Re: Turkey Point Unit 3
Docket No. 50-250
Order (EA-03-009) Relaxation Request
Examination Coverage of Reactor Pressure Vessel Head
Penetration Nozzles - Supplemental Data

**TURKEY POINT UNIT 3 RELAXATION REQUEST
FROM US NRC Order EA-03-009**

RESPONSE TO REQUEST FOR ADDITIONAL INFORMATION

Figure 10 (Note : Results are for a typical plant, not Turkey Point specific)

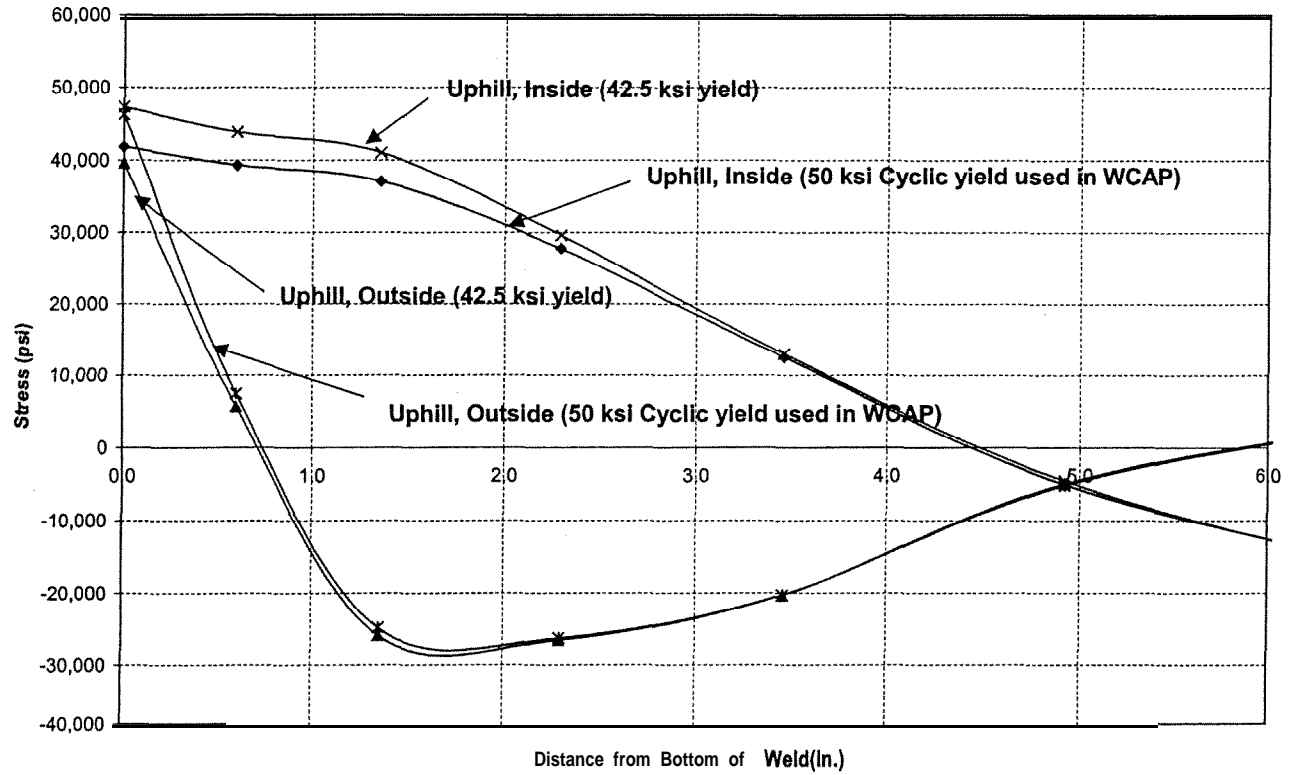
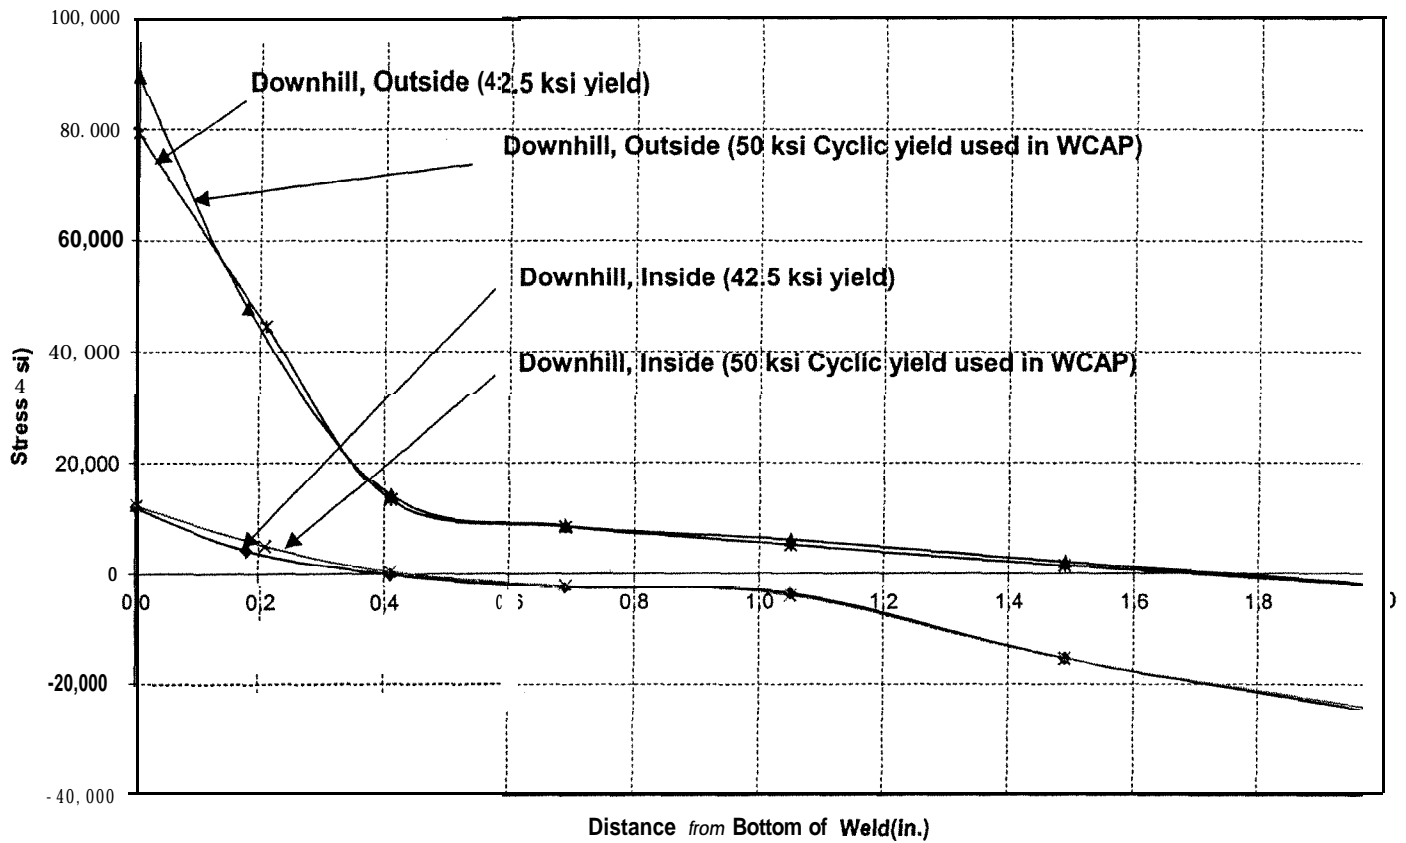
Question 1. In Figures 5-3 through 5-9 of WCAP-16027-P, what is the maximum hoop stress in the nozzle base material greater than one inch from the bottom of the weld? What material properties (i.e., yield strength) were used in these calculations?

Calculations have been performed to compare the results obtained for a lower stress strain curve, corresponding to a monotonic yield strength of 42.5 ksi, on the exact same geometry. The results of the comparison for one of the outermost penetrations is shown in Figures 10 and 11.

The trend in stresses, decreasing with distance below the weld, is the same regardless of the yield strength used. In three of the four cases, the actual stress values are higher for the cyclic stress-strain curve.

Note that the plant depicted in Figures 10 and 11 for this example is not Turkey Point, but the results are typical regardless of the geometry.
